## **ZONING CHANGE REVIEW SHEET**

CASE: C814-00-2063.10 (Wildhorse Ranch PUD #10)      DISTRICT: 1

TO: PUD (amendment to accommodate future ROW for Braker Lane; Establish a Base Zoning District of CS-MU with Additional Permitted Uses and Increased Allowable Height and Floor-to-Area Ratio (FAR) for the portion of the Property between Braker Lane and SH 130; Adjust Private and Public Parkland on the Property; and Modify Applicable City Code Regulations Regarding Cut and Fill and other Environment Regulations)

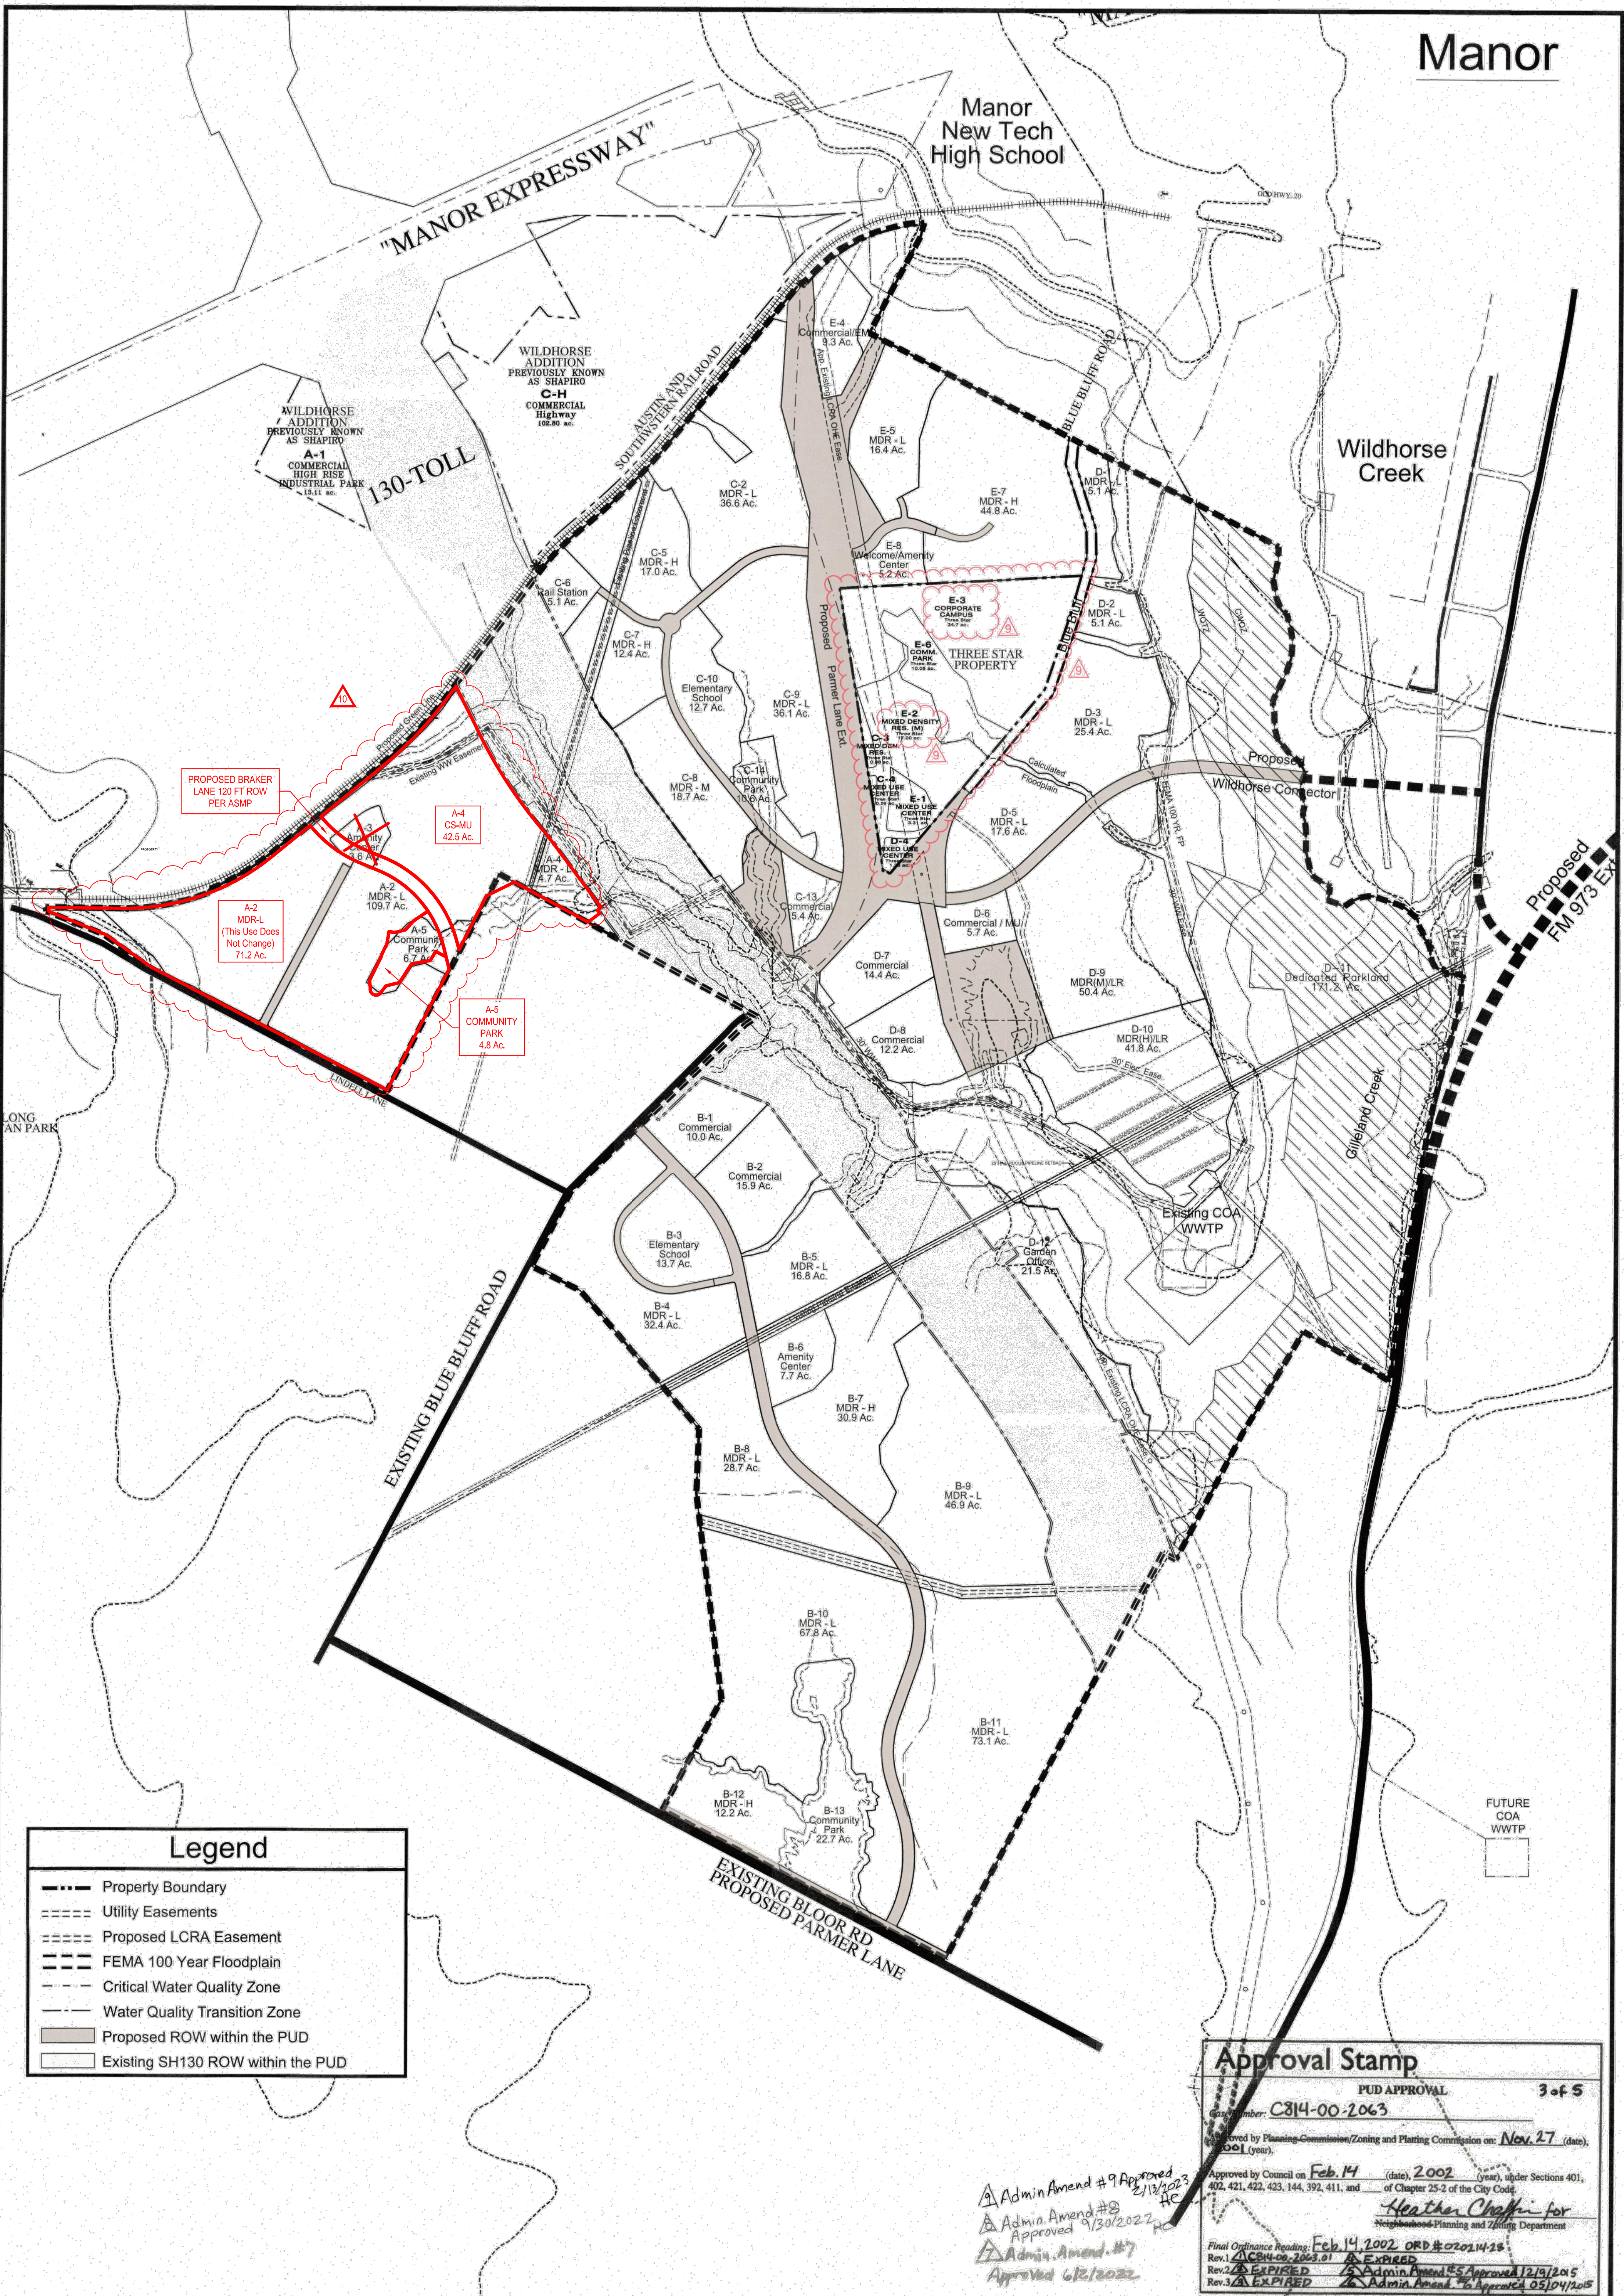
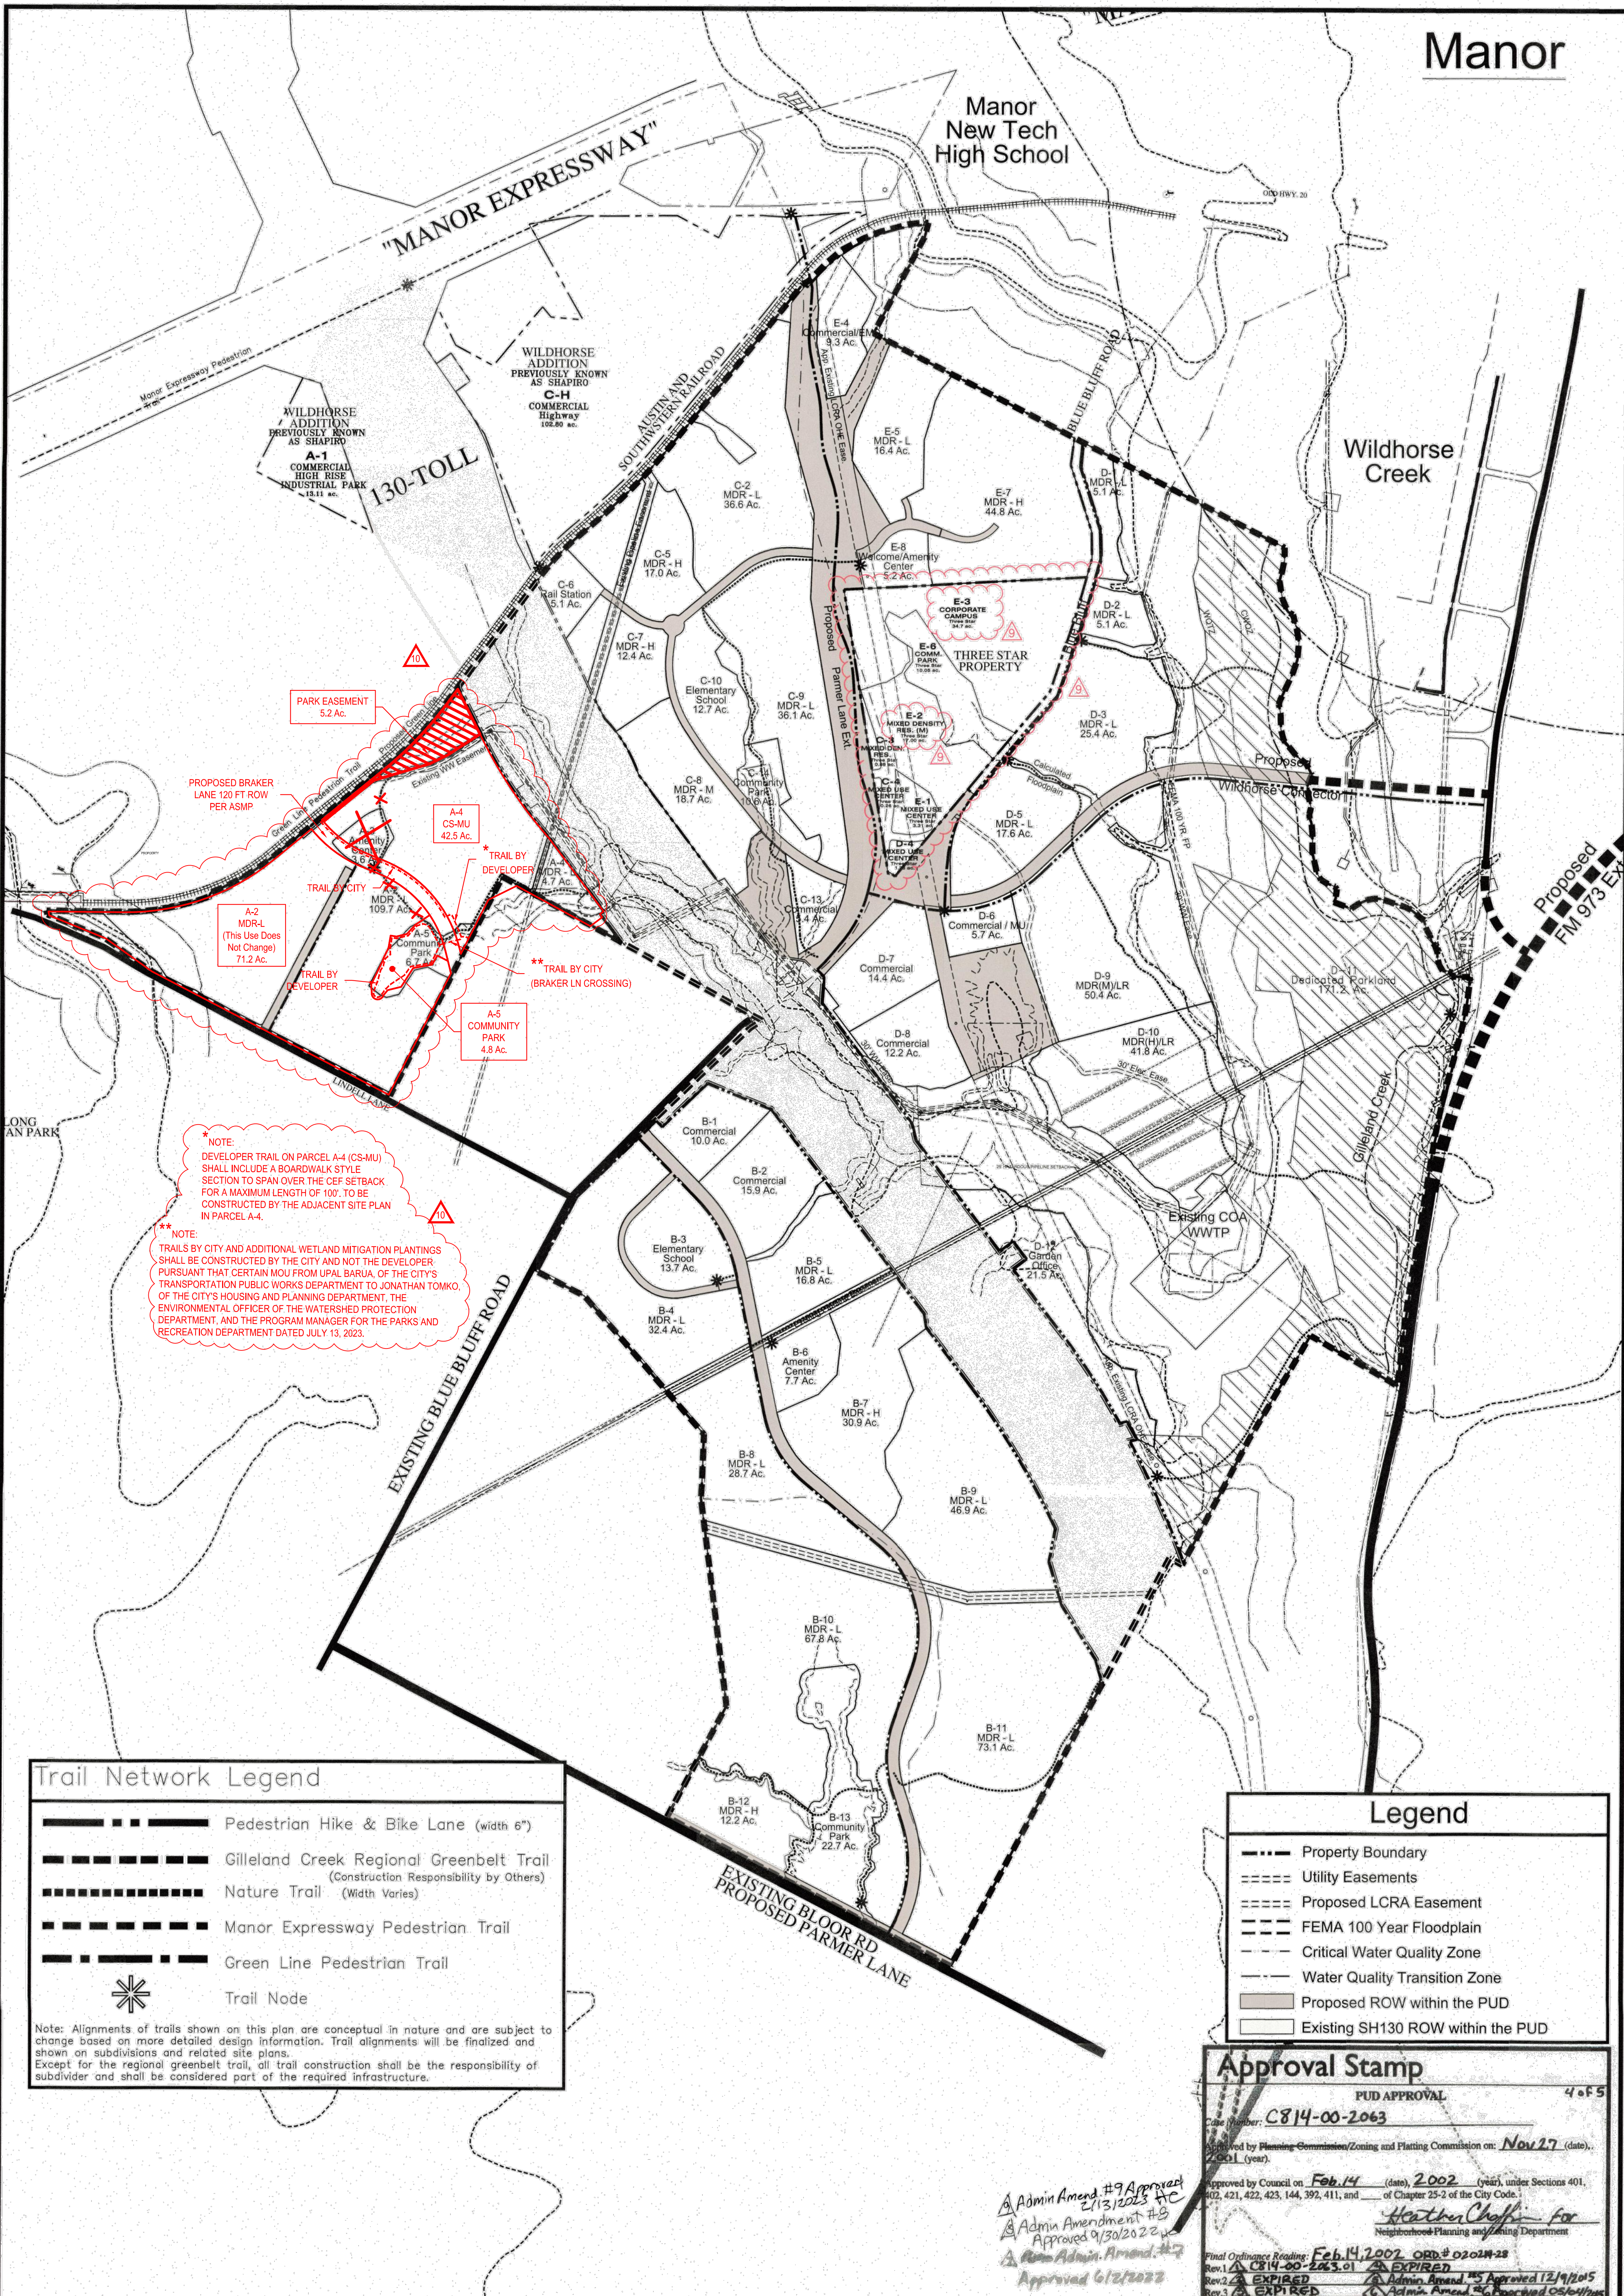
PR1: Please note on the land use plan that the park easement shall be maintained and amenitized by the developer; at minimum, the amenities shall include shade structures, exercise equipment, trails, and/or other amenities as approved by the City of Austin Parks and Recreation Department.

PR2: Please provide clarification that the City will be constructing the “trail by city” within the proposed ROW as part of the new Braker Lane roadway. Confirm that a crossing under the new Braker Lane will be provided to access A-5 community park property.

PR3: The amendment proposes to remove an amenity center, which is a substantial recreational community asset. Please either relocate the amenity center or provide additional recreational amenities that would function as an alternative to the amenity center.

**NOTE:**  
DEVELOPER TRAIL ON PARCEL A-4 (CS-MU) SHALL INCLUDE A BOARDWALK STYLE SECTION TO SPAN OVER THE CEF SETBACK FOR A MAXIMUM LENGTH OF 100'. TO BE CONSTRUCTED BY THE ADJACENT SITE PLAN IN PARCEL A-4.

**\*\* NOTE:**  
TRAILS BY CITY AND ADDITIONAL WETLAND MITIGATION PLANTINGS SHALL BE CONSTRUCTED BY THE CITY AND NOT THE DEVELOPER PURSUANT THAT CERTAIN MOU FROM UPAL BARUA, OF THE CITY'S TRANSPORTATION PUBLIC WORKS DEPARTMENT TO JONATHAN TOMKO, OF THE CITY'S HOUSING AND PLANNING DEPARTMENT, THE ENVIRONMENTAL OFFICER OF THE WATERSHED PROTECTION DEPARTMENT, AND THE PROGRAM MANAGER FOR THE PARKS AND RECREATION DEPARTMENT DATED JULY 13, 2023.
